January 13, 2020

RE: Comments on the Green Apple Renewable Fuels Project Draft Transportation Study

West Coast (PADD 5) Exports of Liquefied Petroleum Gases

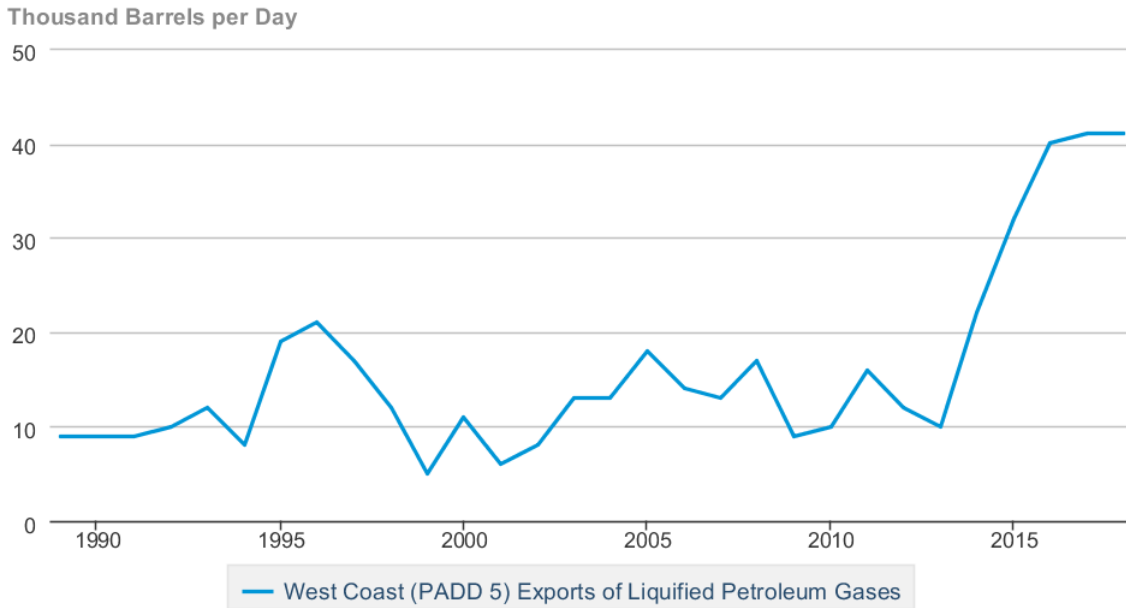
The US Energy Information Administration data shows that the increase in exports from 32 Mb/d in 2015 to 41 Mb/d in 2016 have been maintained in 2017 and 2018.⁷

The VTRA 2015 does not address LPG carriers, and further, does not include a model for the potential consequences of an accident that involves an LNG tanker. Thus, LNG tankers for the purposes of the VTRA 2015 study are minimally modeled for traffic impact as cargo focus vessels only.

A thorough analysis of project-related vessel traffic interactions with the neighboring Petrogas LPG export vessel traffic, and associated risks of accidents and accident consequences should be specifically addressed in the environmental review of this project. LPG carriers, like LNG carriers, could require additional naval architectural analyses to assess the consequences of accidents with these vessels.
